E73 alarm (Input drying NTC failure) on Washer Dryer

DESCRIPTION:

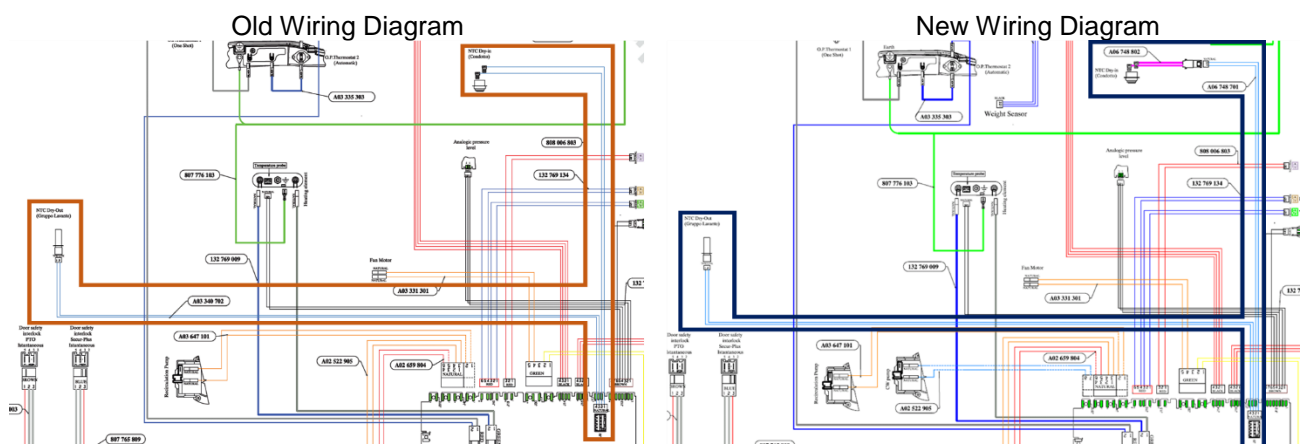
Due to a too relatively thin diameter of the DRY NTC cable, "E73" alarm can happens during the life of the washer dryer. Except for rare cases (to evaluate one to one), it is due to the DRY NTC cable broken/damaged under the black protection tape (especially near the clamp to fix the wiring to the dry aluminium duct).

Here below one example of the old wiring diagram and the new one:

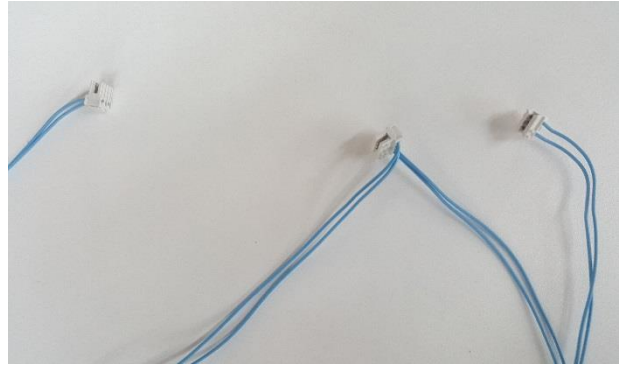
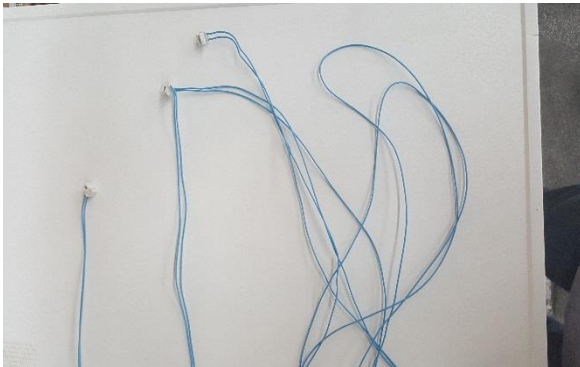
To solve the issue technicians have to remove the DRY NTC wiring (code A03340702 – SP code 140033407028) and they have to order and replace it with this two new one:

- 1) Harness, temperature probe, 470mm code A06748802 – Spare Part code 140067488019;
- 2) Harness, main electronic board, temperature probe, 1760mm+570mm code A06748701 – Spare Part code 140067487011.

1) Harness, temperature probe, 470mm code A06748802 – Spare Part code 140067488019

2) Harness, main electronic board, temperature probe, 1760mm+570mm code A06748701 – Spare Part code 140067487011.
